**NRPA Individual Permit Application – Embankment Repairs and Trail Improvements on Back Cove Trail, Portland, Maine – NRPA Permit No. L-24096-4E-A-N**

We revised the NRPA application submitted on September 4, 2012 for embankment repairs and trail improvements along Back Cove.

Figure 11: Proposed Mitigation Planting Areas

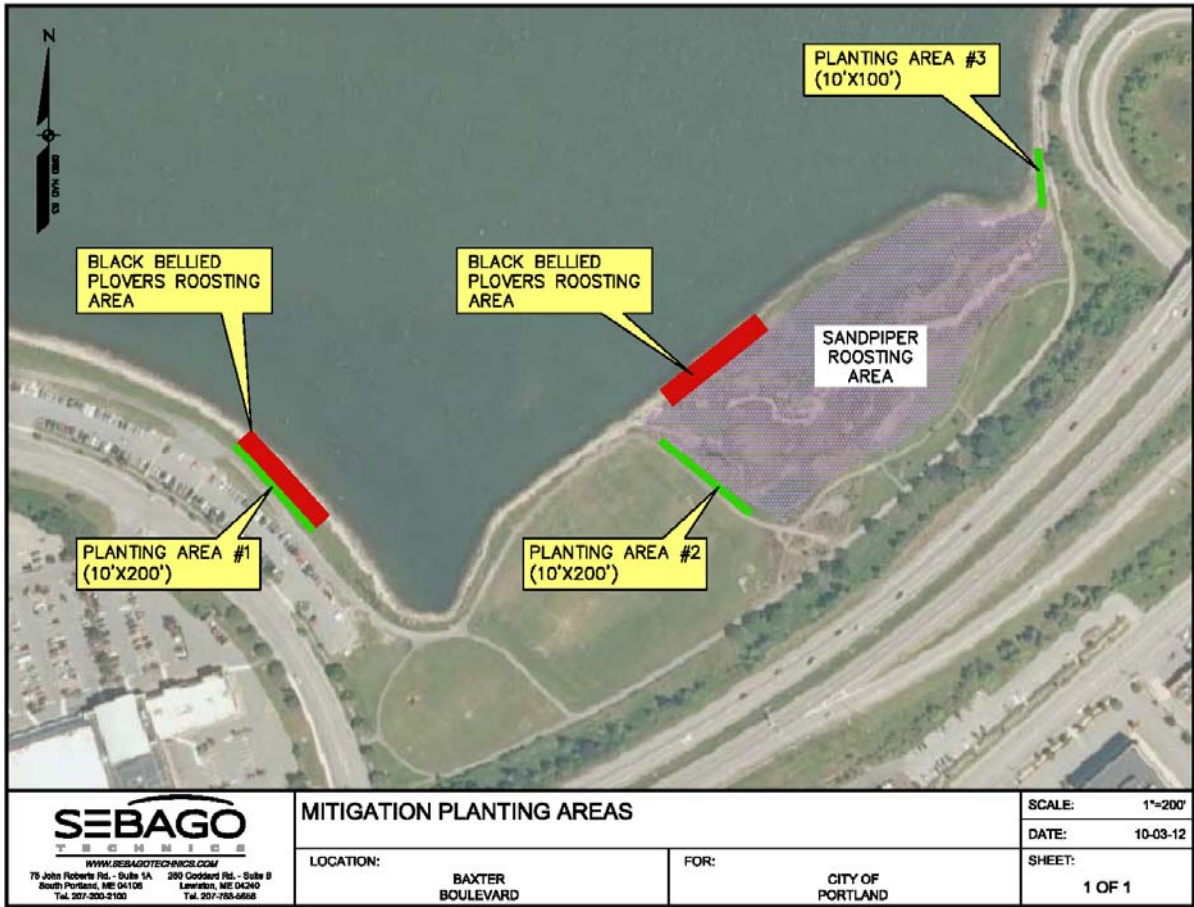
1. As discussed during an onsite meeting, the embankment slope that will replace the failing retaining wall was steepened from 2:1 (H: V) to 1.5:1 (H: V) so that impacts to the coastal wetland are minimized. Revised drawings showing the steepened slope are enclosed.
2. Language was added to the Alternatives Analysis and Avoidance/Minimization Statement (Attachment 2) to show that the proposed 10-foot wide esplanade complies with the minimum standards of Chapter 5-3.1, AASHTO Guide for the Planning, Design and Operation of Bicycle Facilities.
3. The Mitigation Plan (Attachment D) of the original application was revised to show Planting Area #3 adjacent to the trail and north of the sandpipers roosting area.

As part of the prior NRPA permit for retaining wall repairs, the City of Portland agreed to a mitigation plan that included plantings for upland stabilization and screening of waterfowl roosting areas along two sections of the Back Cove recreational trail. The original mitigation plan was revised to include a third section of plantings north of the sandpiper roosting area and along the trail in accordance with IF&W and MDEP. Figure 11 shows the three proposed planting areas and their proximity to the trail, parking lot and field areas.
